MEMORANDUM FOR THE RECORD
APPLICATION# 22 IWC 21
REGULAR MEETING – THURSDAY, OCTOBER 20, 2022
Prepared by Meredith Badalucca, Zoning & Wetlands Officer

Applicant: Watch Hill Builders, LLC
Property Owner: Watch Hill Builders, LLC
Address: 1108 Old Colchester Road (M/B/L 036-005-002), Oakdale, CT
Submitted: September 9, 2022
Date Received by IWC: September 15, 2022 *(DRD 11/19/2022, Tabled until 10/20/22)*

SITE DEVELOPMENT PLAN
 LAND NOW OR FORMALLY
 WATCH HILL BUILDERS, LLC
 OLD COLCHESTER ROAD, MONTVILLE, CT

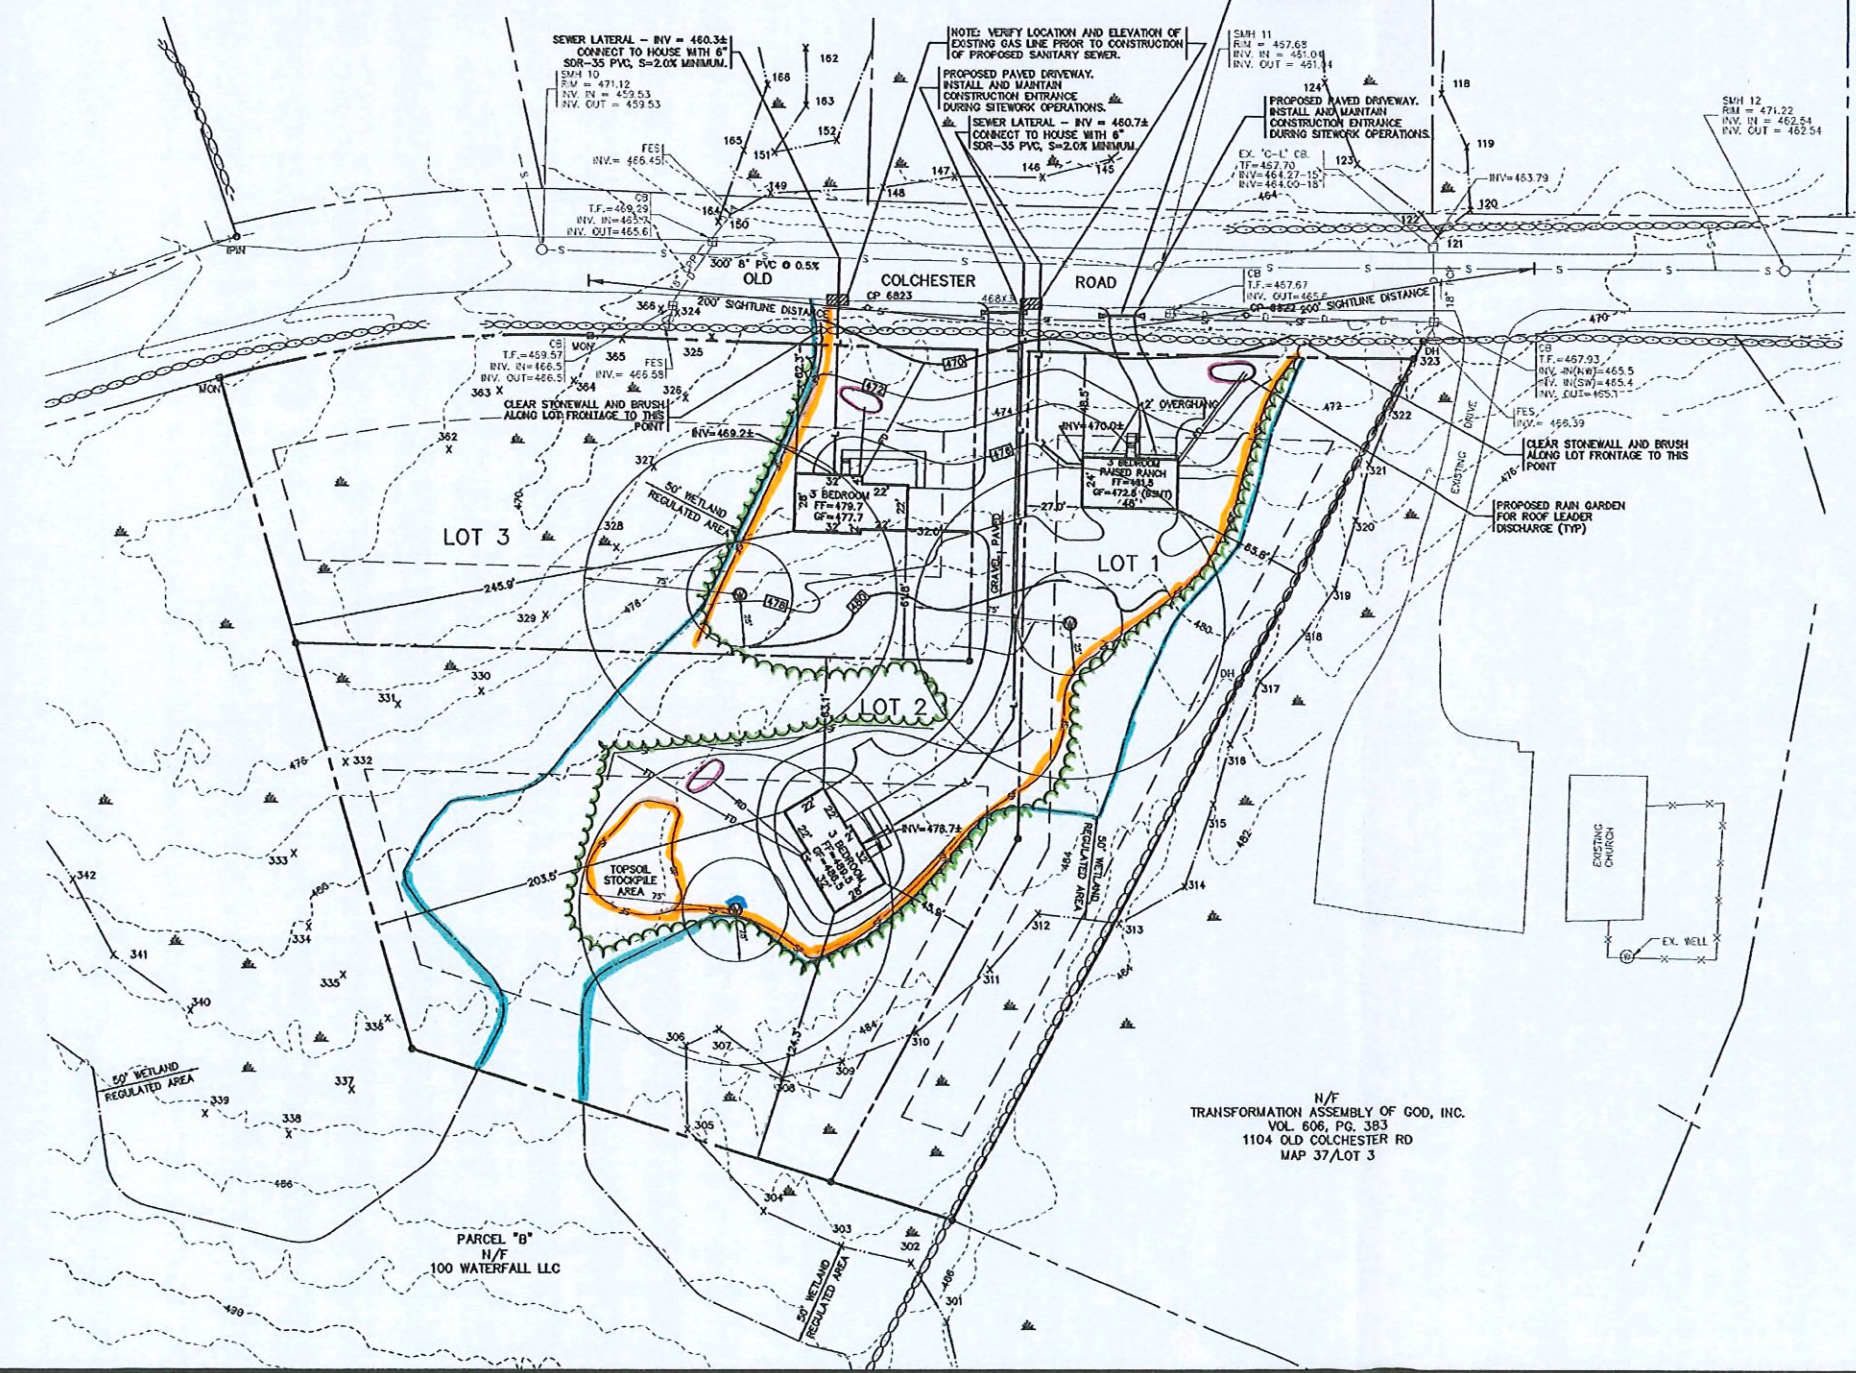
1. The plans indicate that the wetlands were delineated in 1998. The applicant should have the soil scientist confirm that the delineation depicted is still accurate.
2. The plans indicate that the houses will be served by sewer. If dewatering of trenches may be needed, show a dewatering detail.
3. Add woodchips to the silt fence detail.
4. Specify a seed mix for vegetative stabilization.
5. Specify silt sack for the nearby catch basins.

- SILT SACK DEVICES SHALL BE INSTALLED ON ALL CATCH BASINS ALONG THE PROJECT FRONTAGE AND SHALL BE MAINTAINED UNTIL EACH LOT HAS BEEN PERMANENTLY STABILIZED.

- IF DEWATERING OF UTILITY TRENCHES IS REQUIRED, A PROPERLY SIZED PUMP OUTLET SETTLING BASIN SHALL BE UTILIZED AT THE PUMP DISCHARGE.
 - DRIVEWAY CULVERTS SHALL BE CONSTRUCTED OF 18" CLASS V RCP WITH FLARED END SECTIONS AT THE INLET AND OUTLET. THE PURPOSE OF DRIVEWAY CULVERTS IS TO PROVIDE POSITIVE DRAINAGE FLOW IN THE ROADSIDE SLOPE TO EXISTING CATCH BASINS.

NO.	DATE	DESCRIPTION	BY
1	09/27/22	TOWN COMMENTS, HOUSE FOOTPRINT	MJB
